DWP DISTRIBUTION PLAN SUBMITTAL REVIEW

SITE PLAN

VAL HOMES

S/L 10 BARRISTERS COURT VOL. 44 – PG. 4
CITY OF KIRTLAND LAKE COUNTY STATE OF OHIO

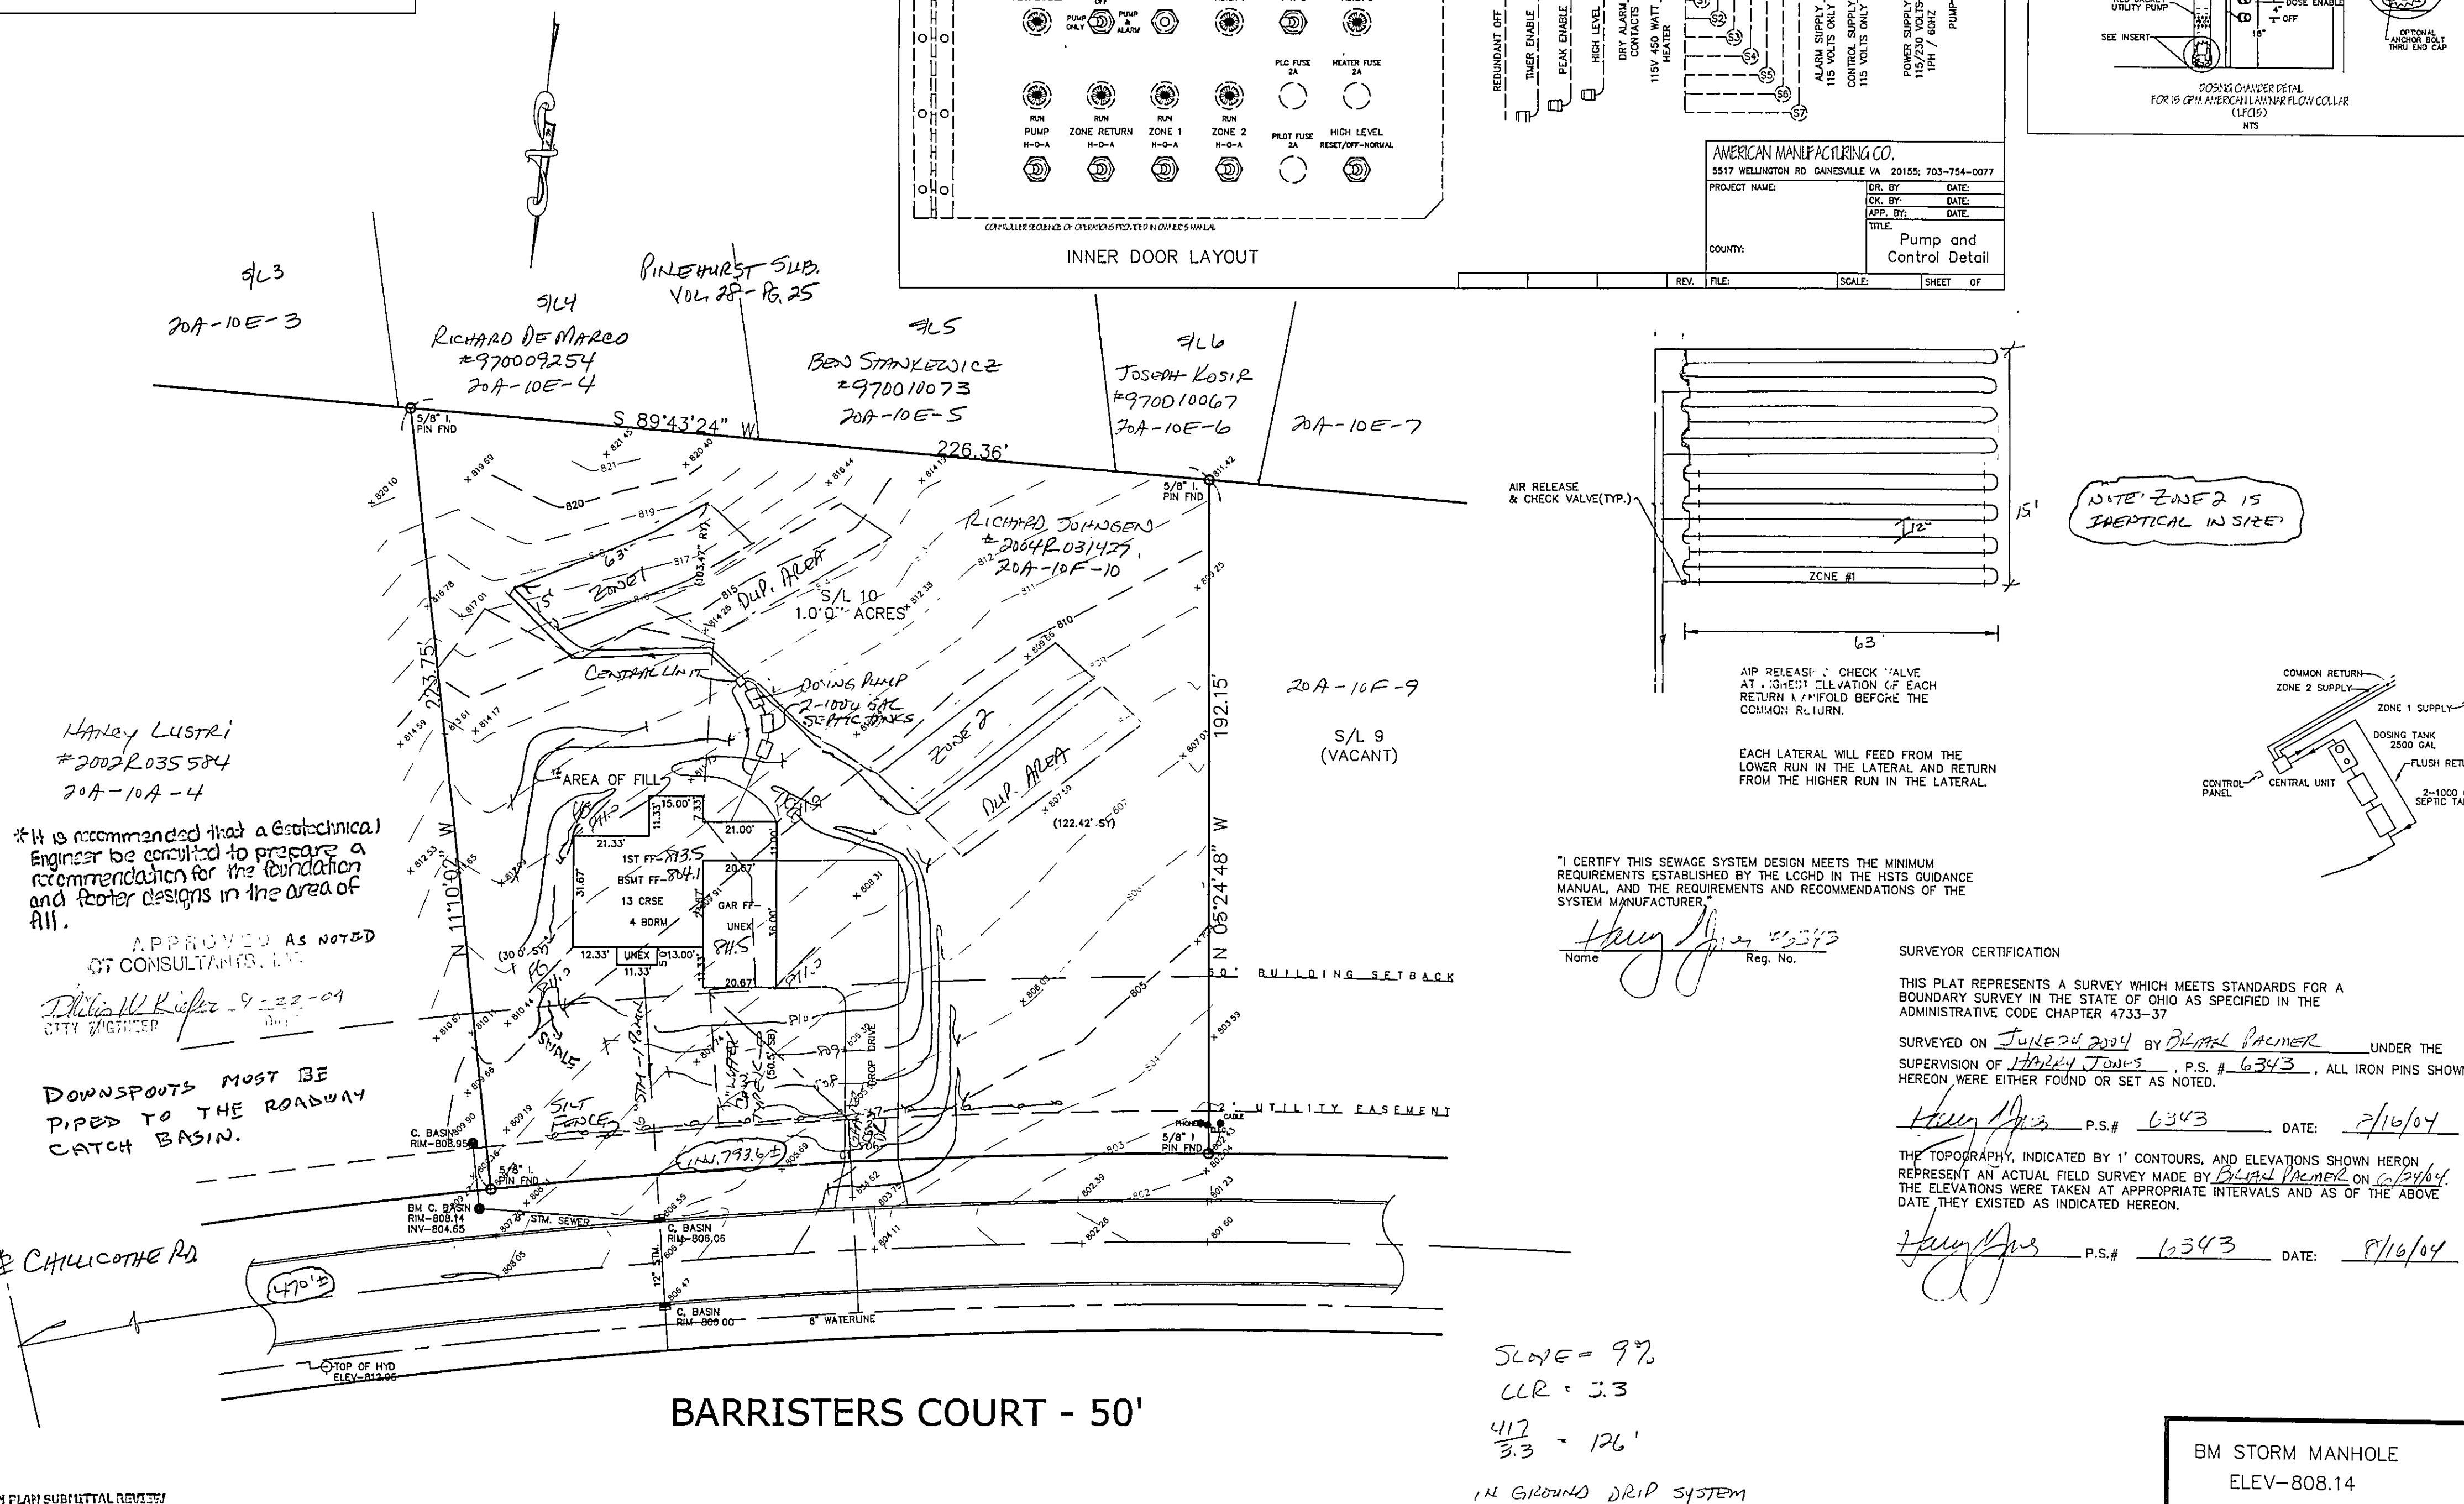
Date 9-14-4 Name Dan O
9.14.4 Dej
9-14-4 DOL
 Move zone 2 25' from
 zone 1
